Addendum 2

City of Canton, Ohio
Purchasing Department
218 Cleveland Ave. SW, 4th floor
Canton, Ohio 44702

36th St NW Storm Sewer & Road Reconstruction, Phase 2, GP 1270

DRAINAGE SUBSUMMARY

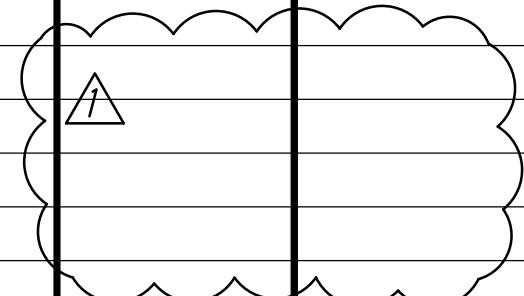
Sheet #22 (drainage subsummary) has structure D-9 listed as a manhole. Sheet #34 shows D-9 as a catch basin, therefore the catch basin and manhole quantities need to be adjusted accordingly.

Sheet #23 (drainage subsummary) it appears 37' (P-26) was not added to the total amount for 15" conduit type "C".

Sheet #23 (drainage subsummary) has 10' of 4" conduit type "C" for U-100 & U-101. The proposed underdrain is 6", therefore should these conduit quantities be listed under the 6" conduit type "F" item?

Sheet #24 (drainage subsummary) it appears 48' (P-18) has been included with 15" conduit type "B". Sheet #38 show this run to be 15" conduit type "C". Which conduit type is correct?

D-9 should be a catch basin, not a manhole. Subsummary, general summary and estimate have been updated.

The total length of 15" conduit Type C should be 121 on sheet 18. Subsummary, general summary and estimate have been updated.

U-100 & U-101 should be the 6" Conduit Type F. Subsummary, general summary and estimate have been updated.

P-18 conduit should be Type C. Subsummary, general summary and estimate have been updated.

STANDARD MODIFIED
DRAWING NO. 20
SANITARY SEWERS & LATERALS
SHEET 1 OF 1

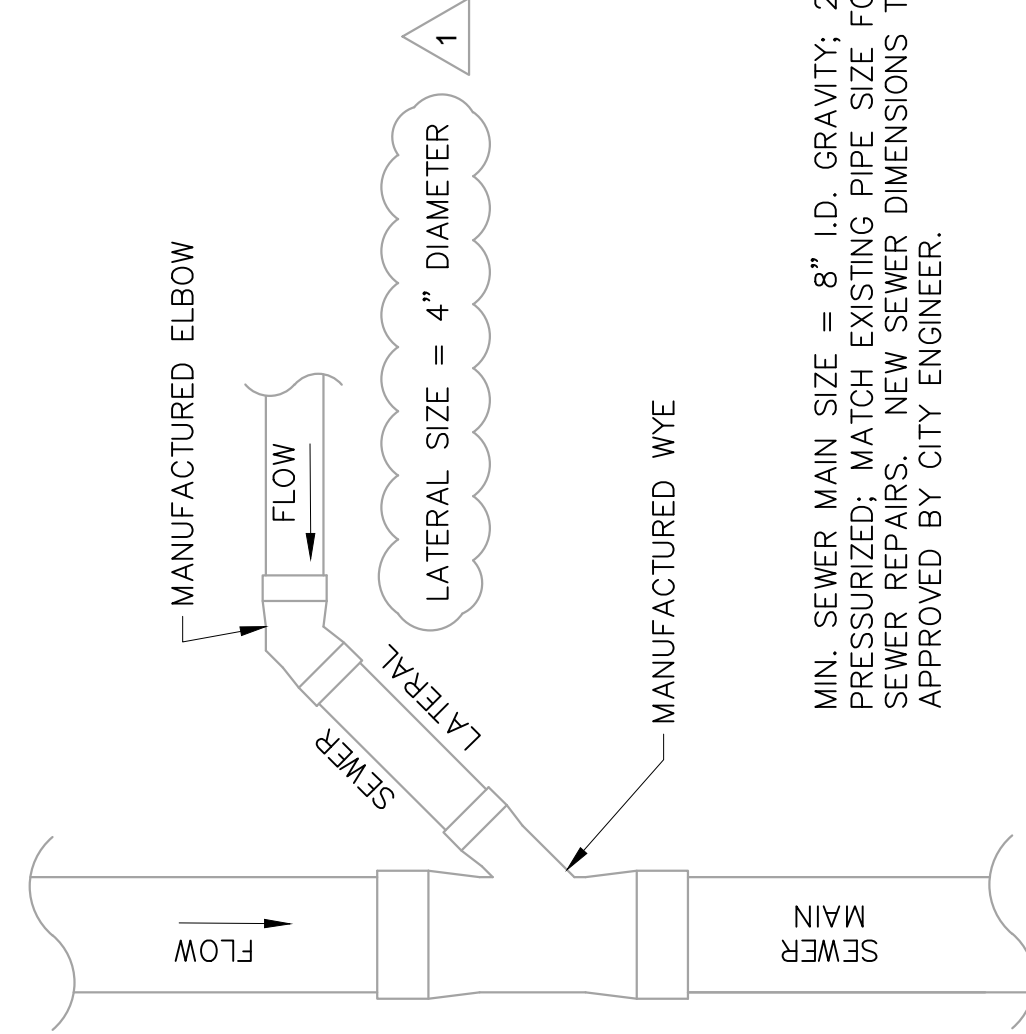
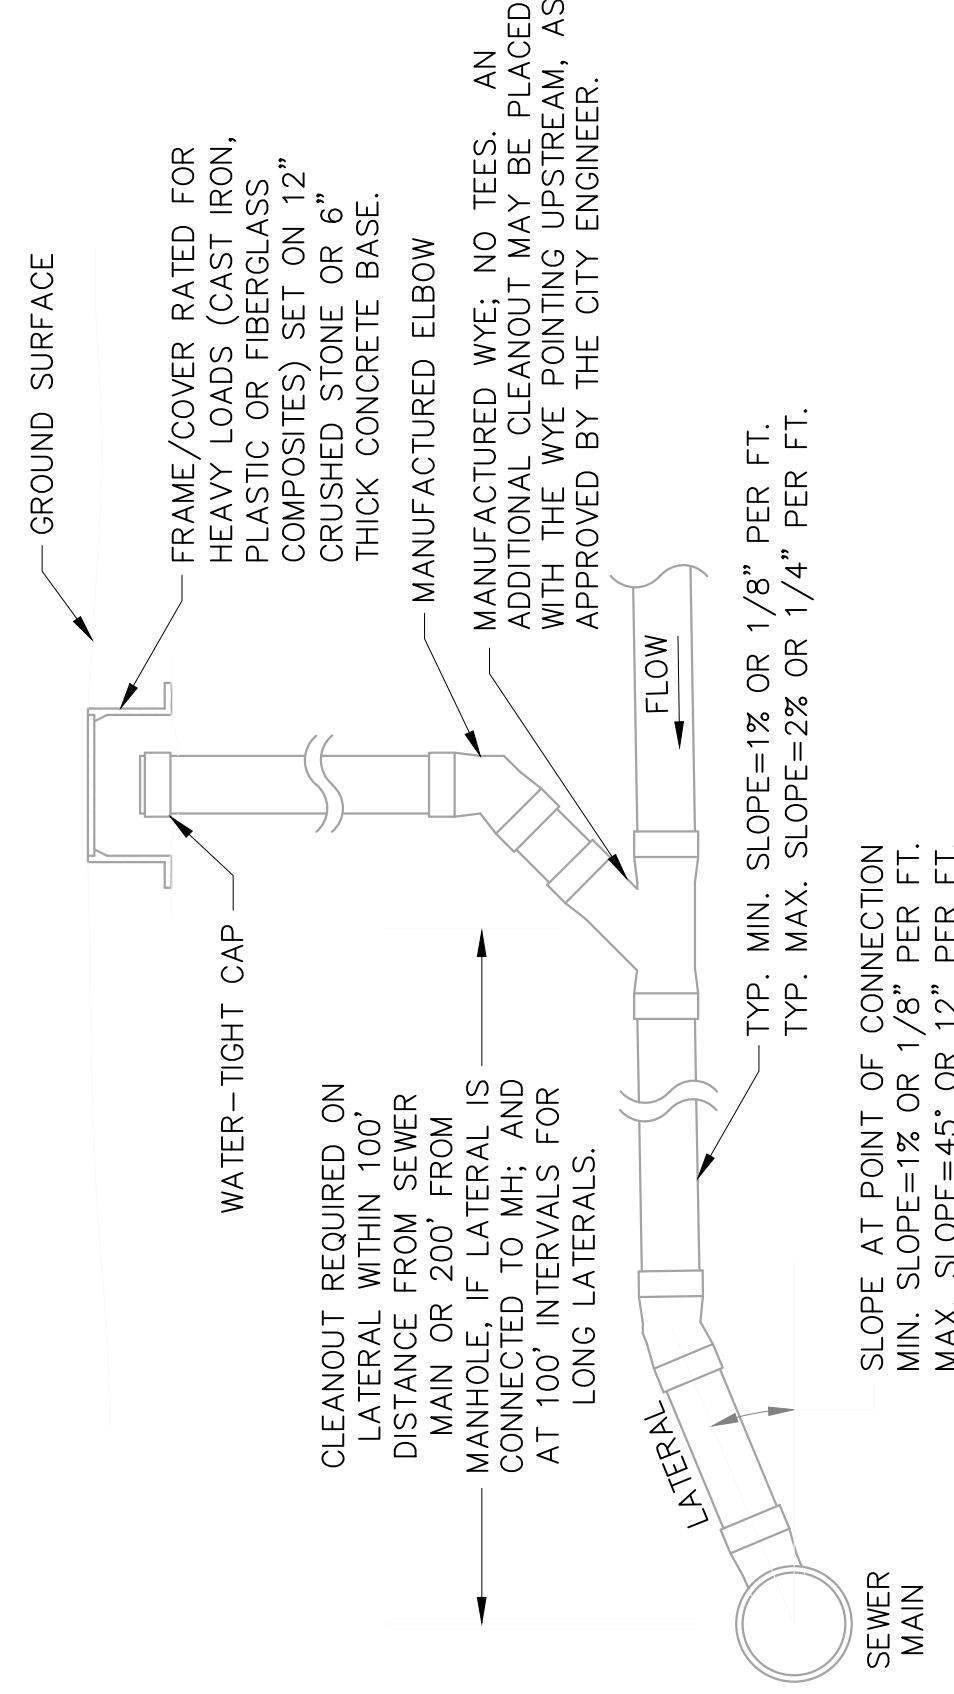
What will the conduit size be required for the reconstruct sanitary lateral items?

Will cleanouts be required for the long reconstruct sanitary laterals? Since there is no bid item for cleanouts, I'm assuming no.

Residential sanitary lateral reconstructs should be 4" diameter. The general notes have been revised accordingly. City Engineering Standard Drawing No. 20 (plan sheet 96) has also been revised.

Cleanouts are required on the long side sanitary laterals. The general notes have been revised accordingly. City Engineering Standard Drawing No. 20 (plan sheet 96) has also been revised.

- ALL PROPOSED SANITARY LATERAL ITEMS SHALL INCLUDE A NEW MANUFACTURED WYE.
- IF AN EXISTING CONNECTION TO THE SEWER MAIN THAT IS NOT IDENTIFIED TO BE REPLACED DOES NOT INCLUDE A WYE AND WILL NOT PROVIDE A STABLE WATER-TIGHT CONNECTION, NOTIFY THE CITY ENGINEER TO DETERMINE IF REPLACEMENT PER ITEM 611 - CONDUIT, MISC. REPLACEMENT OF LATERAL CONNECTION TO SANITARY SEWER MAIN IS REQUIRED.
- SEE PAGE 13 FOR ADDITIONAL REQUIREMENTS ON THE FOLLOWING ITEMS:
ITEM 611 - CONDUIT, MISC.: REPLACEMENT OF LATERAL CONNECTION TO SANITARY SEWER MAIN
ITEM 611 - CONDUIT, MISC.: RECONSTRUCT SANITARY LATERAL - LONG SIDE, AS PER PLAN
ITEM 611 - CONDUIT, MISC.: RECONSTRUCT SANITARY LATERAL - SHORT SIDE, AS PER PLAN
